Southwest Coastal Design Review / Citizen Advisory Committee Regular Meeting Agenda

SOUTHWEST COASTAL DESIGN REVIEW / CITIZEN ADVISORY COMMITTEE

STAFF REPORT

Request: New carport / tool room, accessory to single family dwelling, requiring Major Design Review, per Land and Water Development and Use Ordinance #80-14, Section 4.102 (E)

SITE PLAN

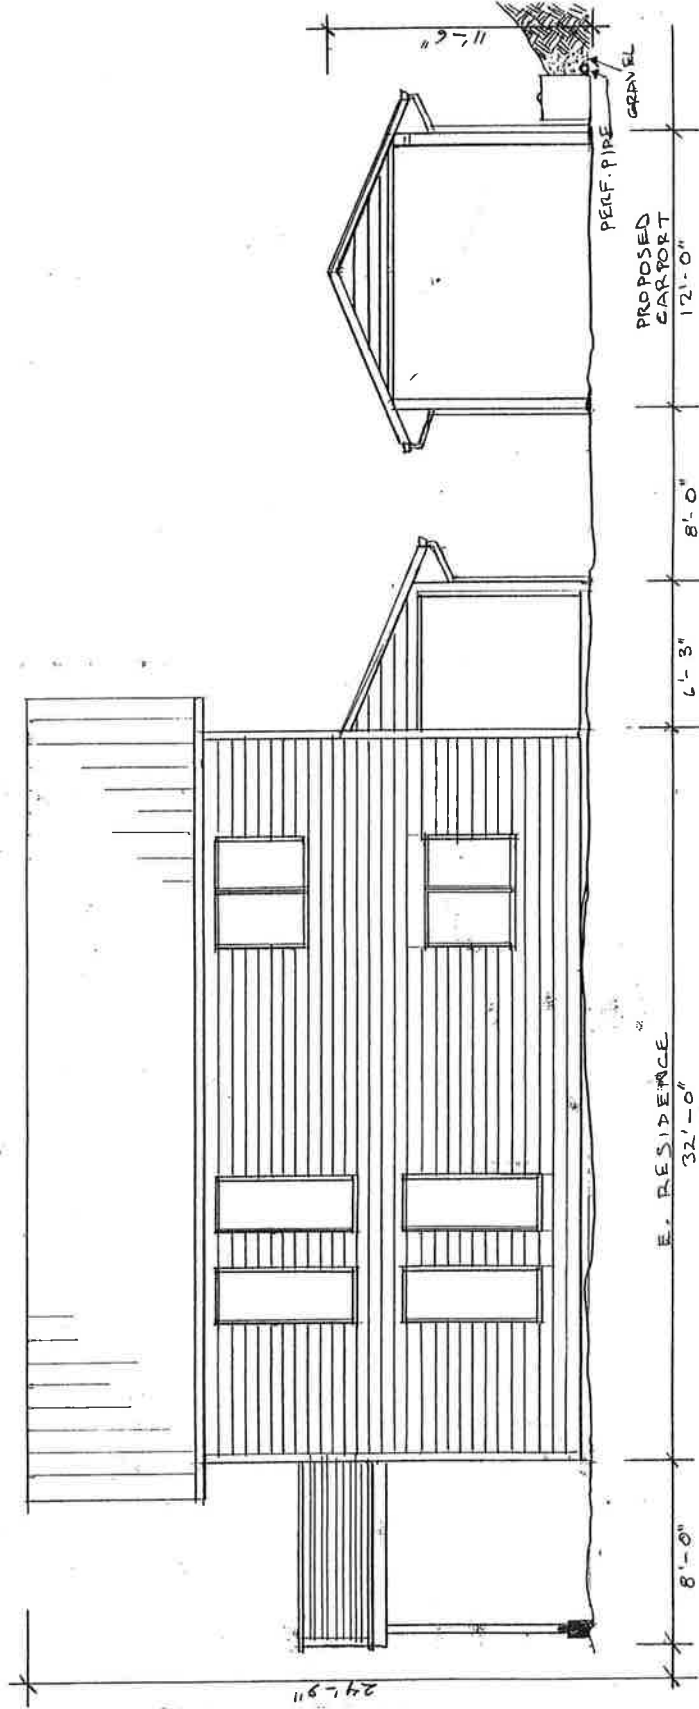
Staff Finding: There will be very little change to the landscape. The site for the structure, according to the applicant, is relatively flat now and requires only minimal grading. The site plan shows land contours and where perforated pipe will collect run-off from the hill above the structure and direct it away from both the accessory structure and the home.

Finding: Staff concurs with applicant. Surface water drainage would be improved, and the proposed plan directs water away the road and nearby homes.

8. Surface water drainage shall be connected to the existing subsurface drainage system for the existing house, as described above.
9. Natural vegetation shall be retained to the maximum extent possible. Only vegetation necessary for the request will be removed.

ELEVATION - SOUTH W/ EXISTING RESIDENCE AND PROPOSED CAR PORT
SCALE $\frac{5}{16} = 1'-0"$

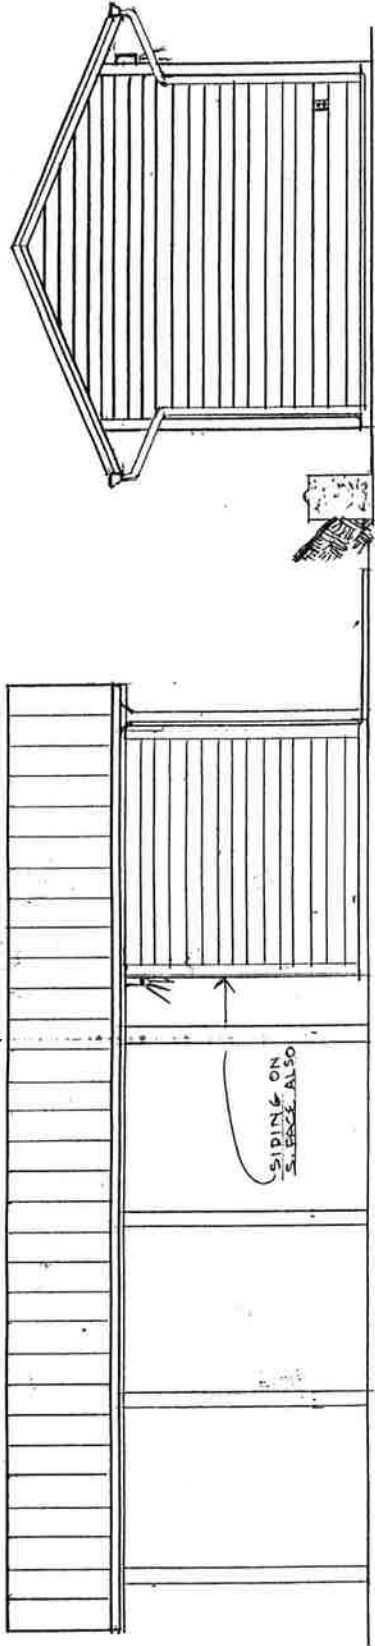
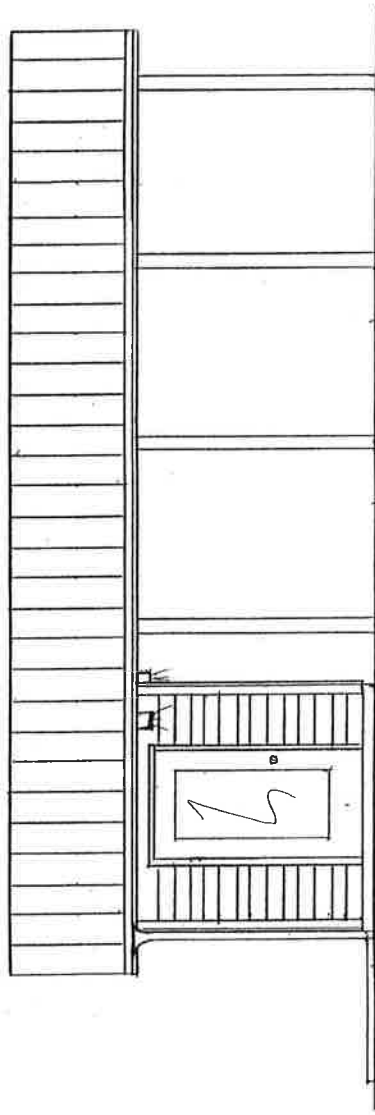
The height of the proposed structure is 11 feet, six inches, less than half the height of the 24-foot, nine-inch house.

Size of proposed structure would be eclipsed by existing house except from north and south, which are forest currently and would not be ocean view. Size of structure conforms to code, as do setbacks.

Tennessee TL 4400 2011 Aerial

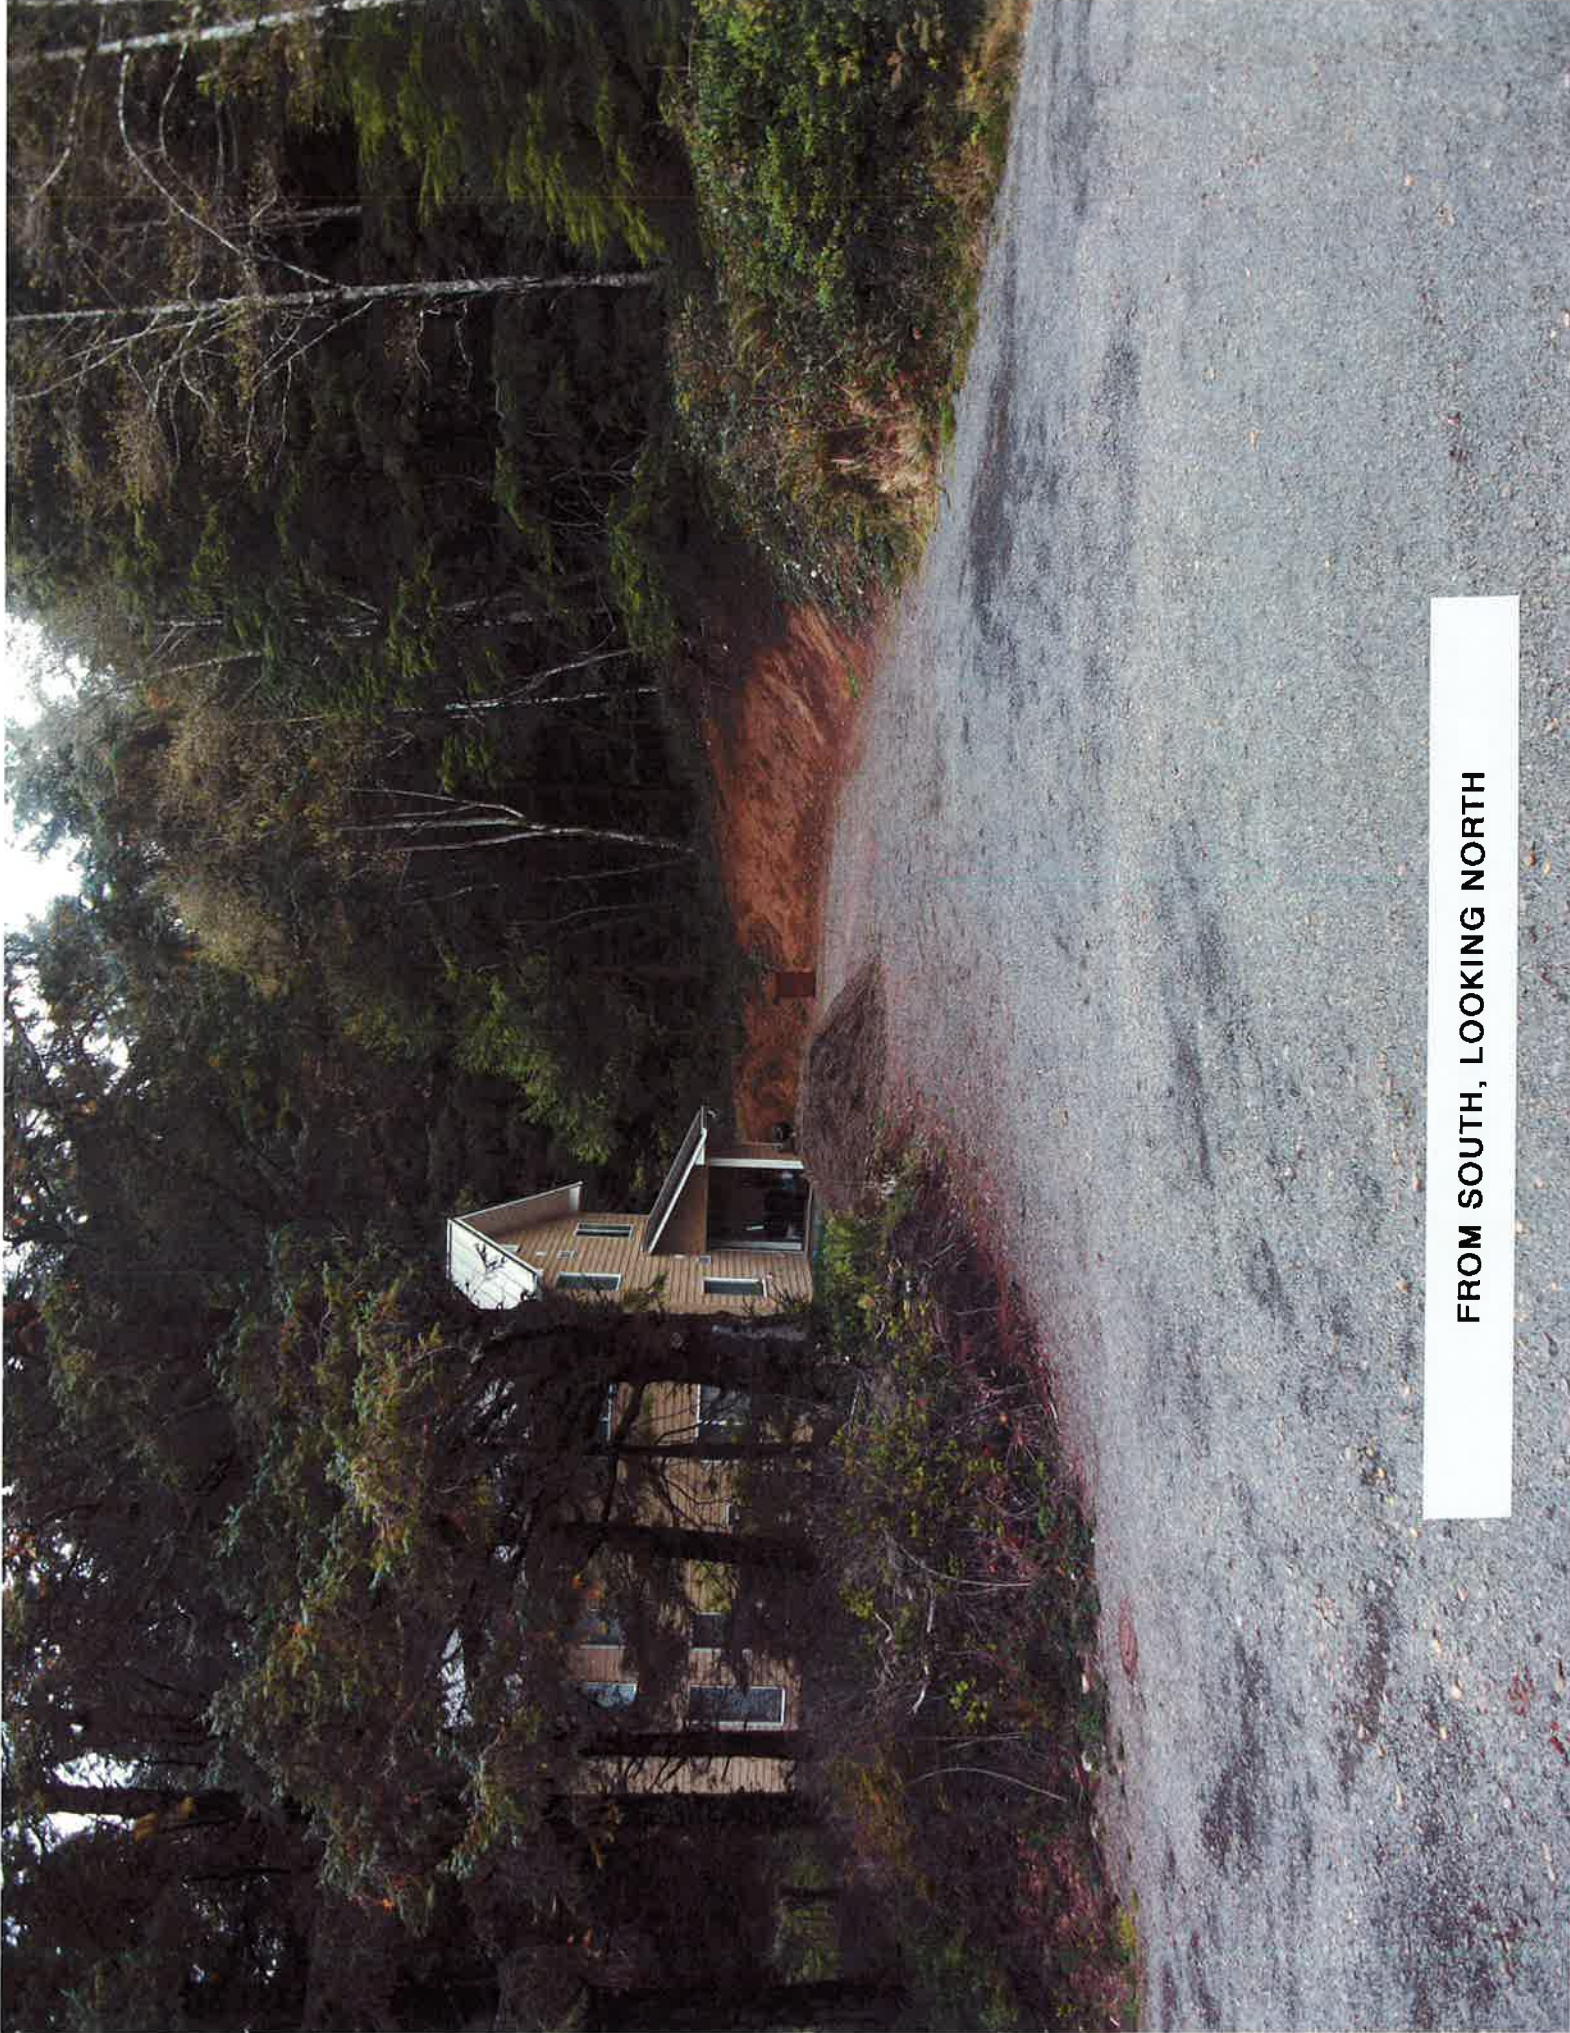
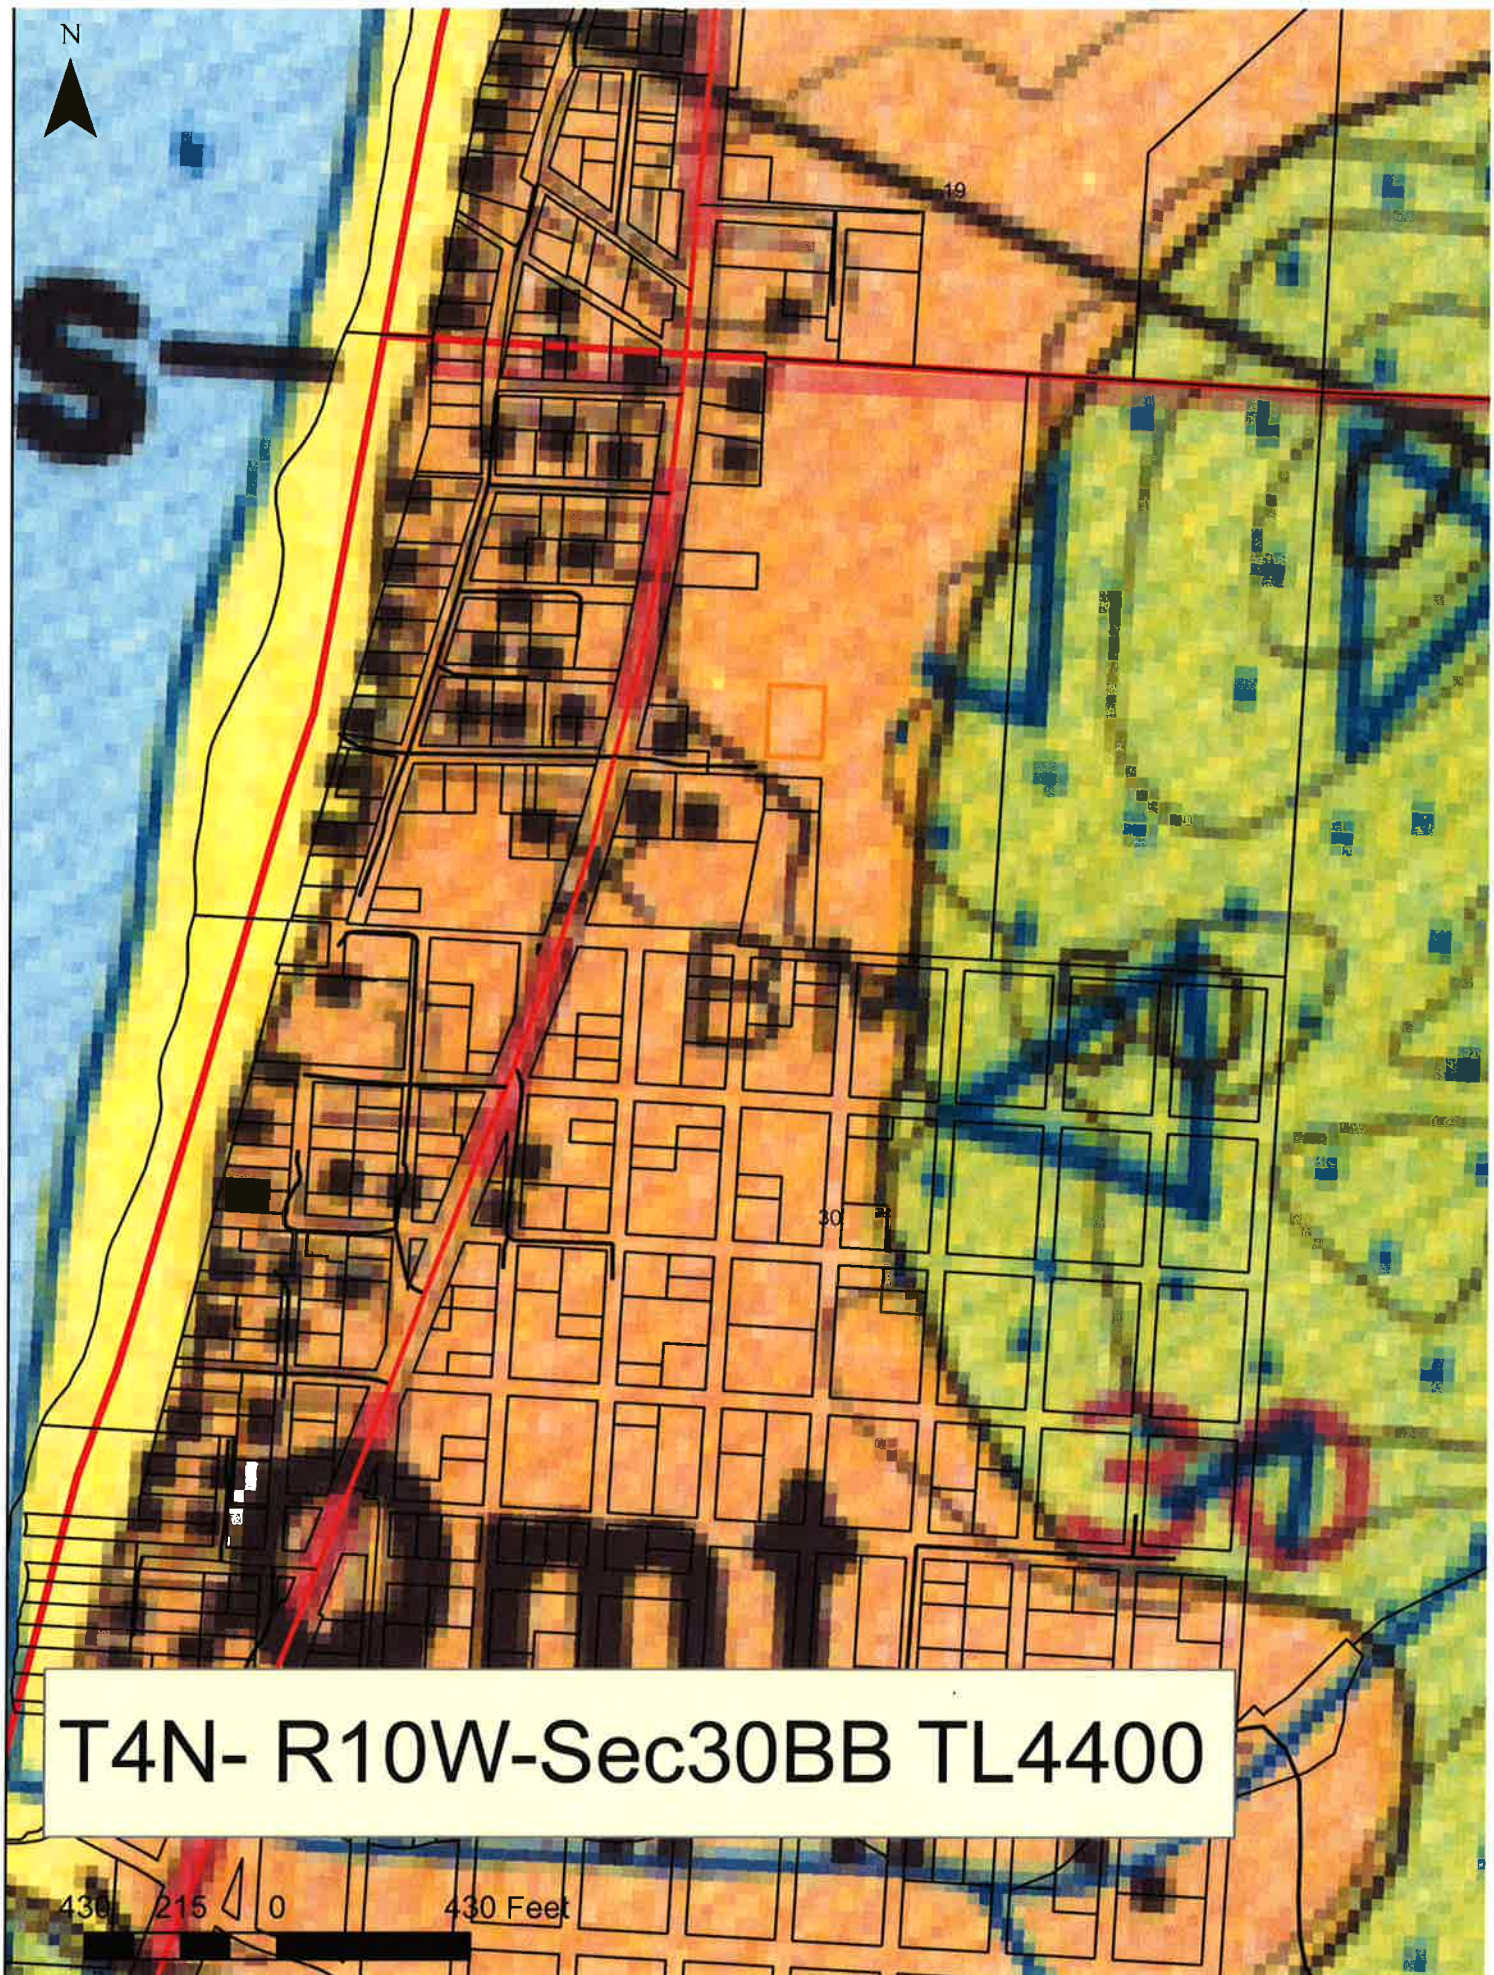
Review of the application and Criterion 1, above, show the proposed structure to be of the type and size permitted. Additionally, review of the aerial photos and site photos submitted by the applicant indicate no ocean views exist that would be blocked by the proposed structure. It should be noted that public notice was provided to property owners within 250 feet of the property lines of the parcel. **No written comments were received.**
